Name of Work: Provision of Illumination for Apron, Isolation bay & Car parking area of ATC Tower at Diu Airport, Diu.

Subject: In-principle approval of Scheme from Planning Directorate-reg.

Proposal received by Deptt. of Planning for granting in-principle approval of High Mast Towers near New Apron, Old Apron, New ATC Tower, Car Park and Isolation Bay at Diu Airport.

HIGH MAST CLEARANCE-APRON

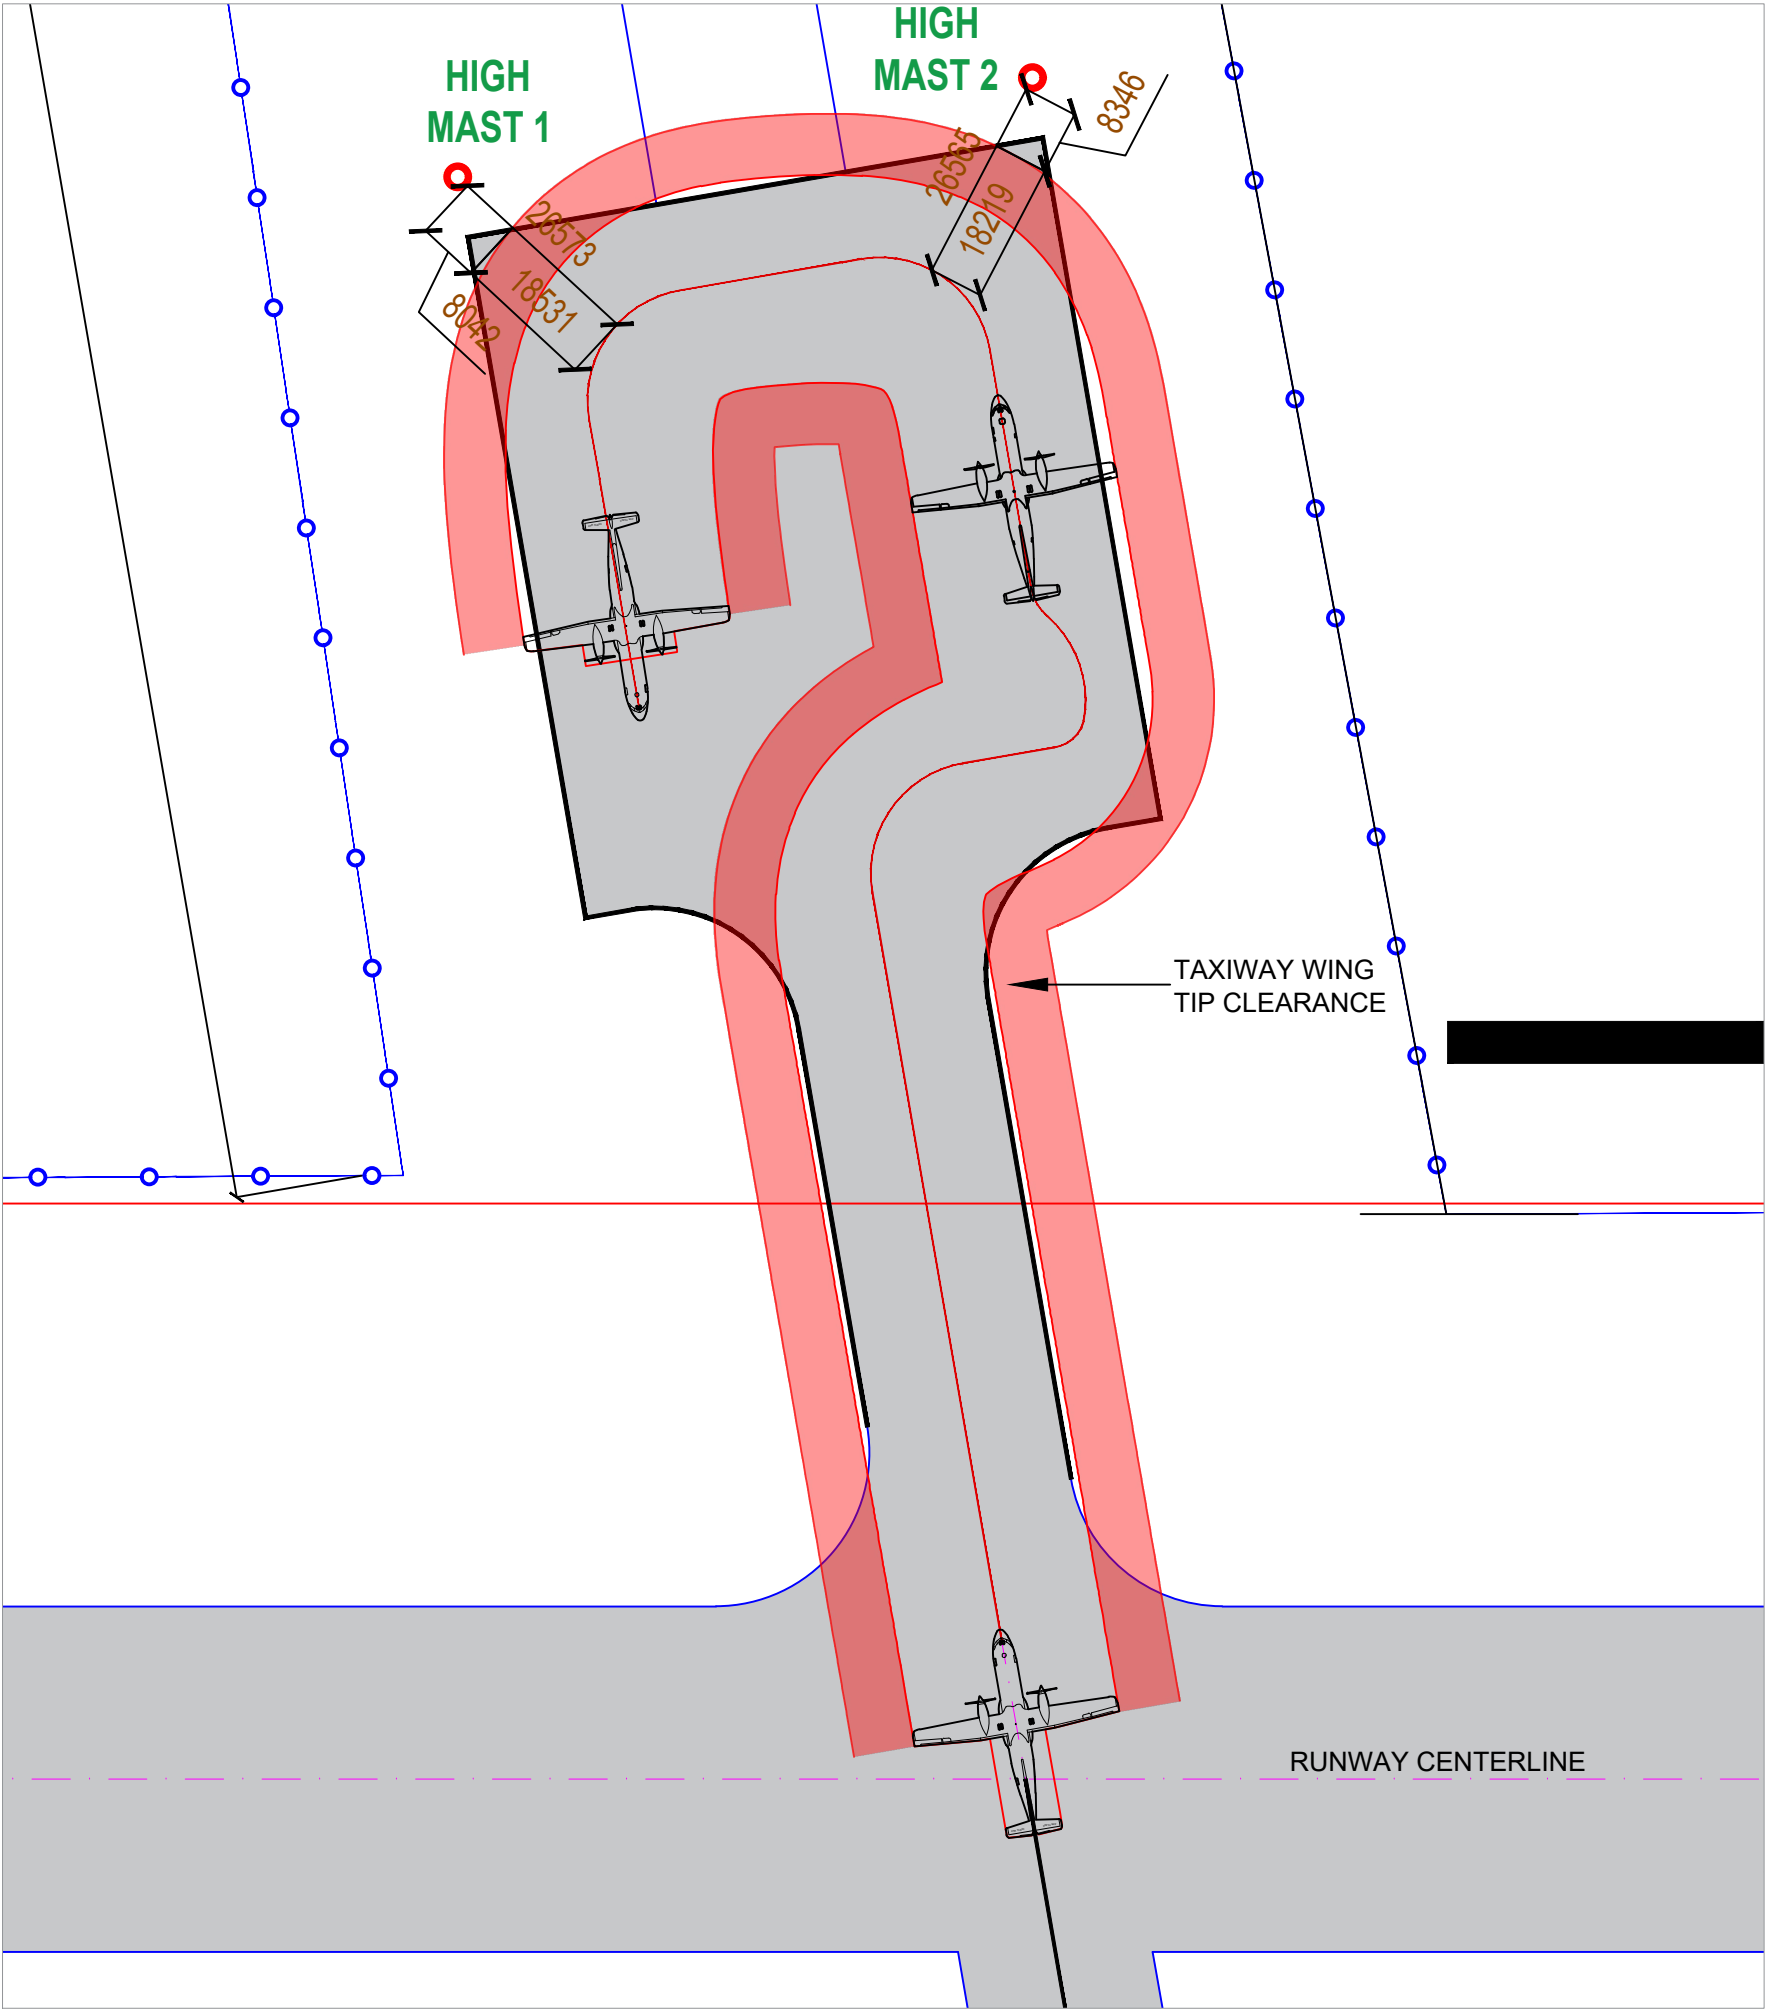
Deptt. of Planning has no comments/ objections to High Mast Towers near Old Apron, Car Park and New ATC Tower as these are not fouling with the airside operations and is in-principally agreed.

As regards the locations of high Masts near New Apron and Isolation Bay, on request of Deptt. of Planning AutoCAD drawing of the locations were received from the station and the same was incorporated in the Master Plan drawing. The Part Plans and Master Plan are attached.

The Diu airport runway is capable of handling Code C (ATR-72 type of aircraft). The drawings indicate that all the high Masts around New Apron and isolation Bay are more than 26mtrs away from the apron centre line as per DGCA CAR.

Therefore Deptt. of Planning in-principally agrees to the location of the high masts around New Apron and Isolation bay also.

HIGH MAST CLEARANCE-APRON

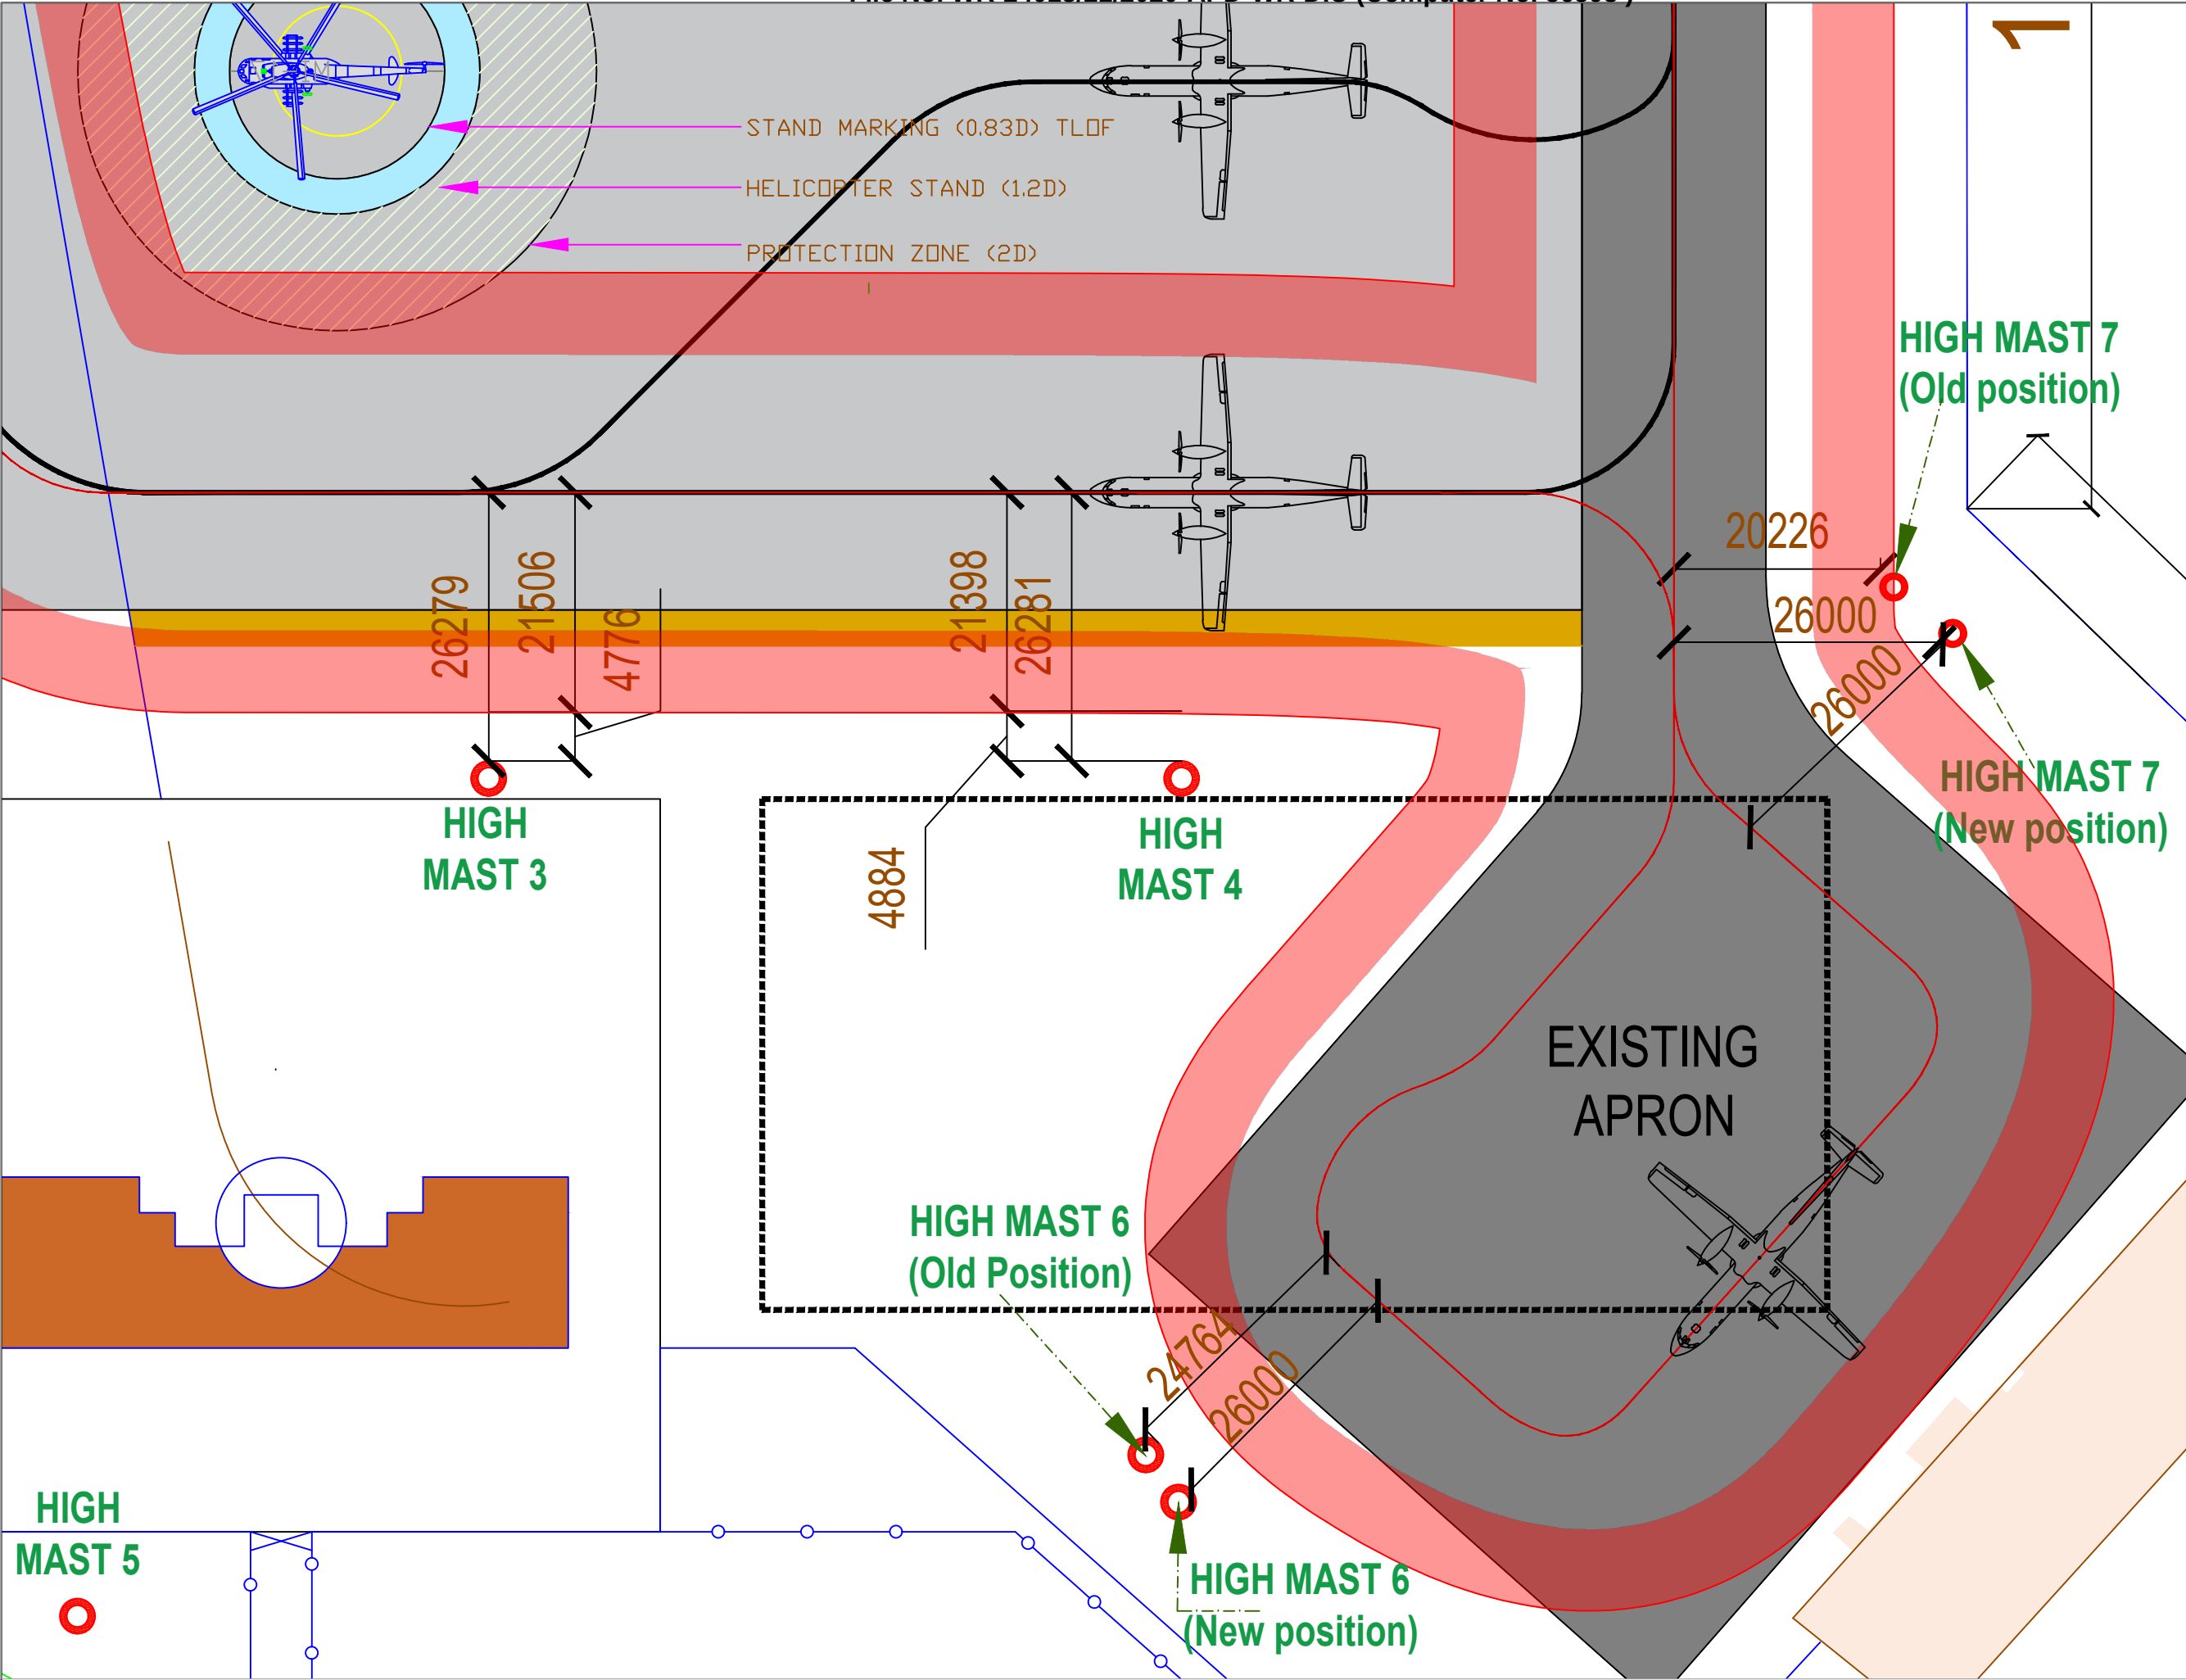
In continuation to the Note-17 of the undersigned and comments of ED(arch) in Note-18. The location of High Mast No. 6 (along old apron) and 7 (along taxi track) has been reviewed and revised location has been marked in the attached plan considering 26m from the centerline of the apron/ Taxi track.

Therefore all the locations of High Mast have been reviewed and agreed except No. 6 and No. 7. For which revised locations are attached.

The location of High Mast have been reviewed and found in order, The High mast no 6 and 7 have been re positioned for meeting the criteria of DGCA CAR for which the drawing has also been enclosed. Submitted for further necessary action please.
